Submission of Further Information

**S.16 Application for
Proposed Temporary Warehouse (Excluding Dangerous Goods Godown) with Ancillary
Office for a Period of 3 Years and Associated Filling of Land in “Agriculture” Zone,
Lot Nos. 209 S.A ss.1, 209 S.A ss.2 and 209 S.A RP in D.D. 110,
Yuen Long, New Territories**

Comments from Drainage Services Department dated 10.5.2024

Plan 8.1 (P 22089)

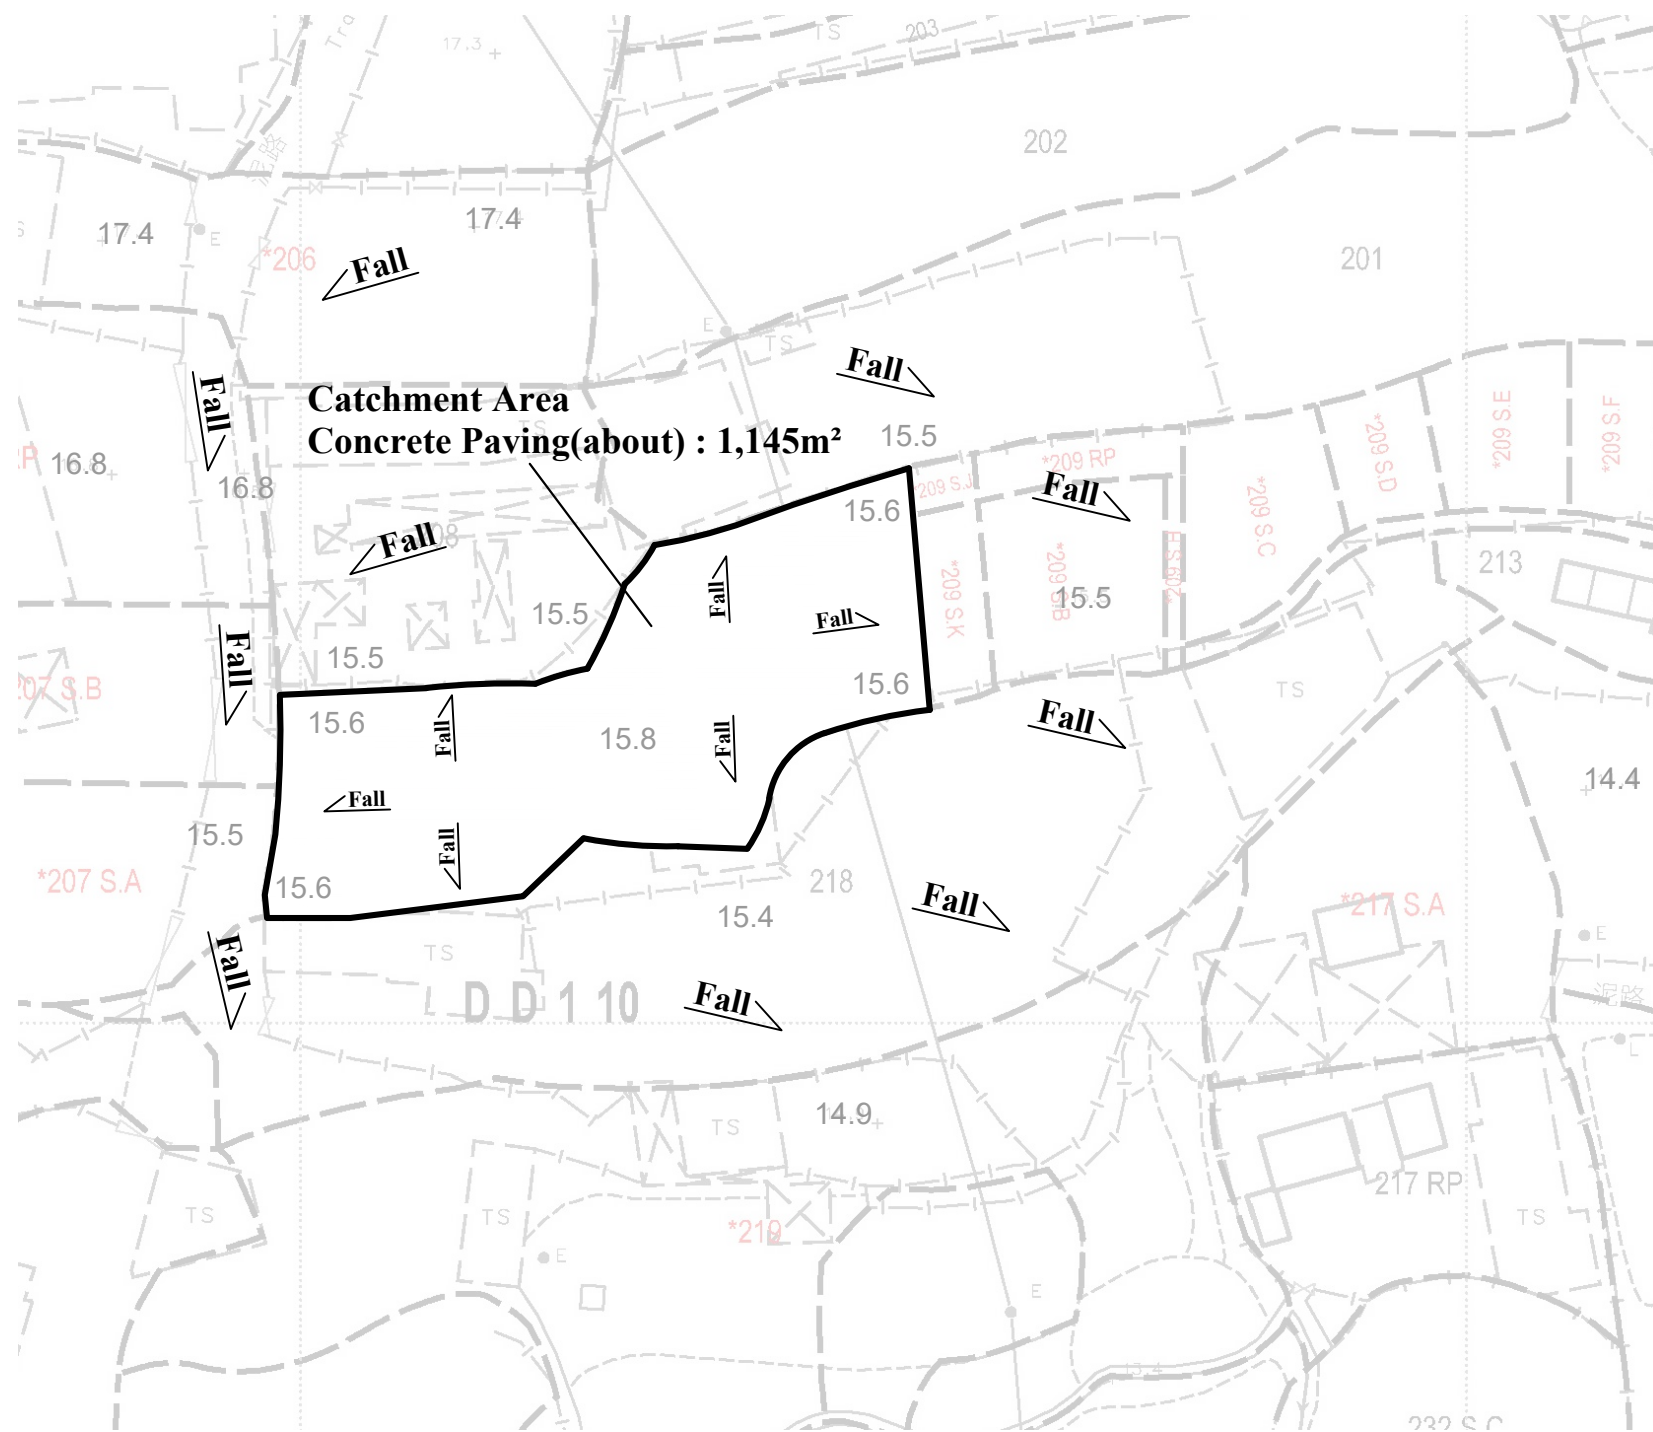
Comments	Responses
(i)	The gradients of the proposed u-channel should be shown on the drainage plan.	The gradients of the proposed u-channel are indicated on the drainage proposal (Plan 8.1).
(ii)	Please advise if any site formation/ land filling works to be carried out under this application. Please note that the overland flow from the adjacent lands should not be affected.	No site formation/ land filling works will be carried out under this application.
(iii)	The invert levels of the start points of proposed u-channels should be shown on the drainage plan.	The invert levels of the start points of proposed u-channels are indicated on the drainage proposal (Plan 8.1).
(iv)	The proposal should indicate how the runoff (the flow direction) within the site would be discharged to the proposed u-channel.	The flow directions within the site are indicated on the drainage proposal (Plan 8.1 and Plan 8.2).

Comments	Responses
(viii)	Cross sections showing the existing and proposed ground levels of the captioned site with respect to the adjacent areas should be given.	No site formation/ land filling works will be carried out under this application. Cross sections are indicated on the drainage proposal (Plan 8.1).
(ix)	The development should neither obstruct overland flow nor adversely affect existing natural streams, village drains, ditches and the adjacent areas, etc.	Noted.
(x)	The applicant(s) shall resolve any conflict/disagreement with relevant lot owner(s) and seek LandsD's permission for laying new drains/channels and/or modifying/upgrading existing ones in other private lots or on Government land (where required) outside the application site(s).”	Noted.
